## Planning Board Meeting Agenda

RE: TX25.10.01 - Fence and Pool Ordinance Update

RE: Stallings Streetscape Amendment

# **ADDENDUM**

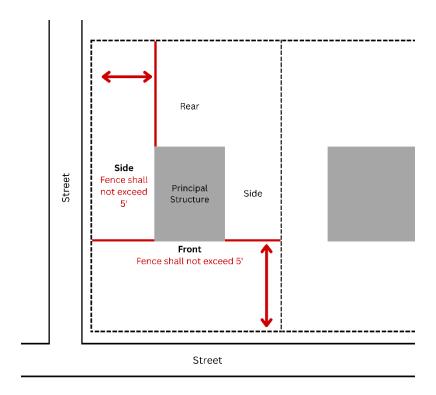
(F.) In a residential or mixed-use district, a fence or wall in an established front or side yard that abuts a street or alley on a corner lot shall be a maximum of five (5') feet in height.

# **GREENWAY**

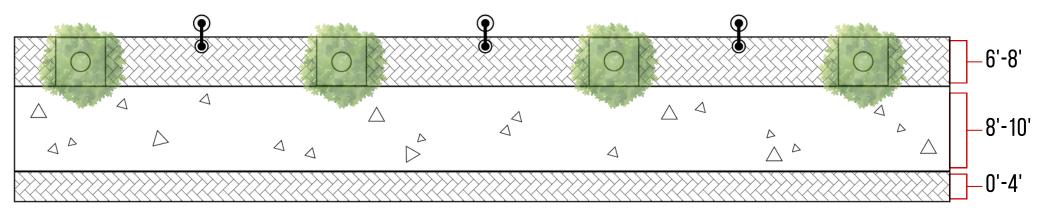
- 6'-8' WIDE PAVER STRIP
- 10'-14' MULTI-USE PATH
- 0'-4' ADDITIONAL PEDESTRIAN ZONE
- TOTAL WIDTH: 16'-26'

- 6'-8' WIDE PAVER STRIP
- 10'-14' MULTI-USE PATH
- TOTAL WIDTH: 16'-22'

# **TYPICAL**

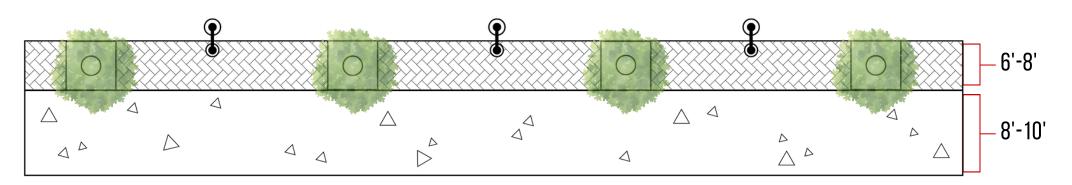
- 6'-8' WIDE PAVER STRIP
- 8'-10' MULTI-USE PATH
- 0'-4' ADDITIONAL PEDESTRIAN ZONE
- TOTAL WIDTH: 14'-22'

- 6'-8' WIDE PAVER STRIP
- 8'-10' MULTI-USE PATH
- TOTAL WIDTH: 14'-18'
